<b>Interview Summary</b>	<b>Application No.</b> 09/911,614	<b>Applicant(s)</b> KOUNO ET AL.
	<b>Examiner</b> Michael K. GRAY	<b>Art Unit</b> 3746

Date of Interview: 21 October 2003.

Claim(s) discussed: 2,5 and 13.

FIG. 1.

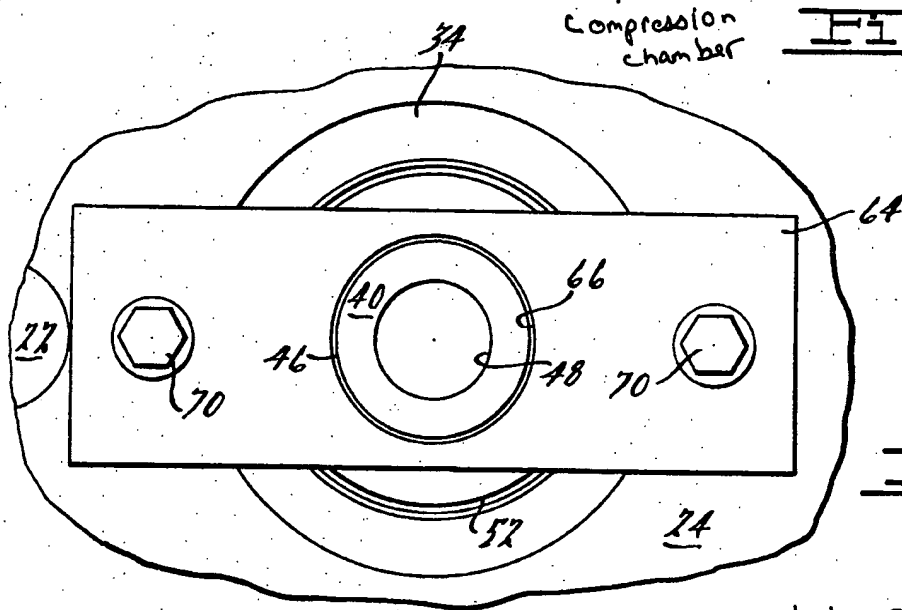
The examiner reiterated discussion with his supervisor regarding the Amendment filed September 21, 2003. An information disclosure statement would be required from the applicants if the applicants desire that the prior art discussed in the specification to be considered. In the drawings, in Figure 1a, lead lines should be provided elements 2 and 3 or the reference numerals should be placed on the applicable elements (37 C.F.R. 1.84 (q)). Other drawing figures should be reviewed in the same light, especially Figures 2, 6 and 21. In independent claims 2 and 13, examiner indicated more language is needed to define a gap which exists between a section of the projection portion and the valve seat. In claim 5, line 14, "provided the end plate" should be changed to --provided in the end plate--. With regard to claim 13, it was discussed whether the claimed "spherical portion" was the proper term and if the claimed portion as shown in Figure 2 (element 17a) is really spherical.
